# R.F. Willson Building Mechanical & Electrical Upgrade Project Invitation to Bid Inquiries and Responses

Issued: 5/14/2019

Figure 1: Q#25 - Duct Penetrations

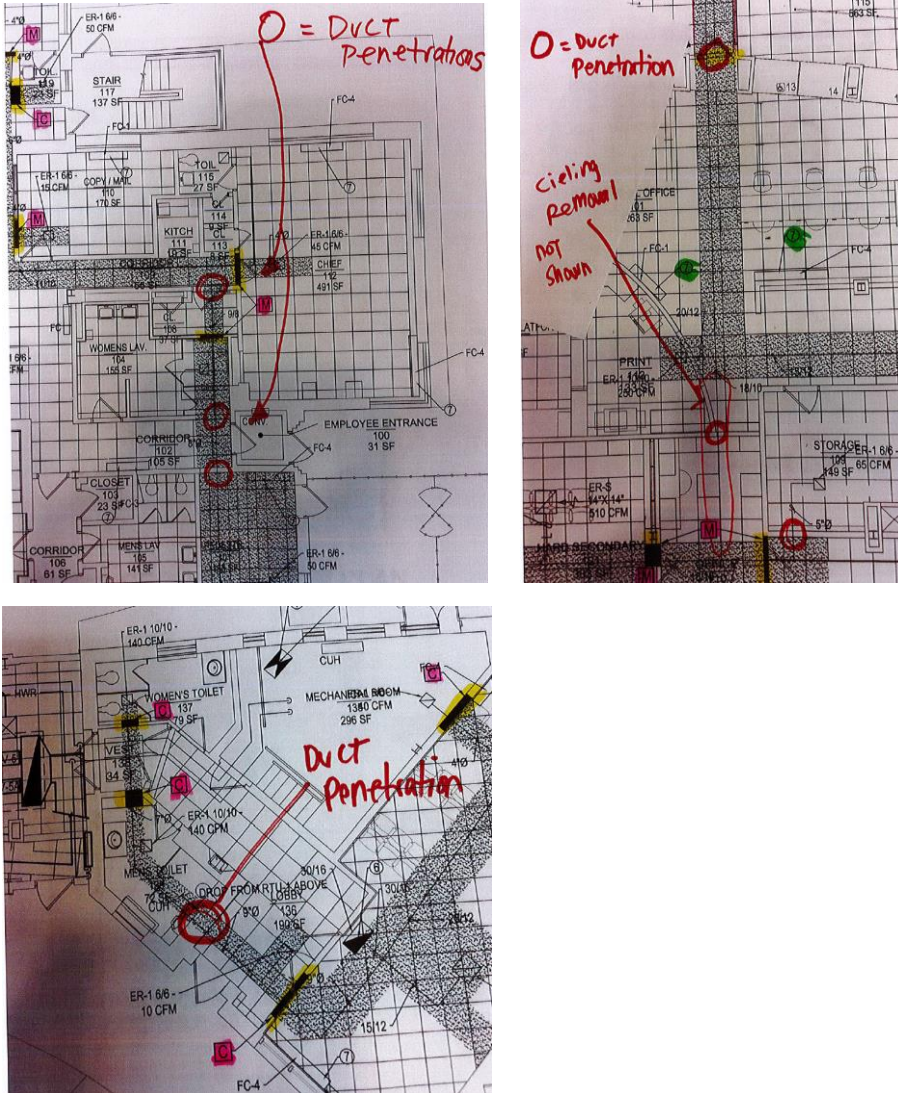
Q#25) The 3 attached [see below, Fig. 1] photos come from drawing A102 and show ductwork penetrations through walls that are not notated on drawings (as all others are). Would be nice to know though if information is easily available whether they are masonry or drywall openings.

A#25) See Addendum No.1 – Item 6 for missing wall identifications.

Figure 2: Q#28 - Roof patching

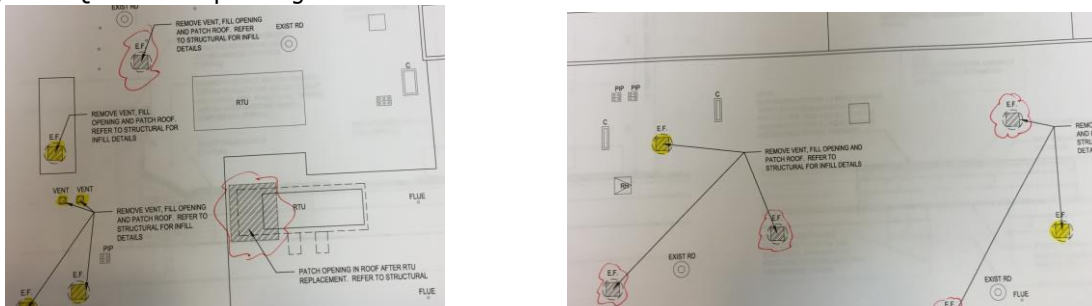
Q#28) The items circled in red specifying patching of roof deck and roofing from Drawing A401 are not shown on either drawing MD-103 or M203. Therefore we assume we are only patching the roof as coordinated with the HVAC drawings. Please confirm. (The items colored in yellow do agree with the HVAC drawings).

A#28) See Addendum No.1 – Item 8 regarding corrections to sheet M-203.
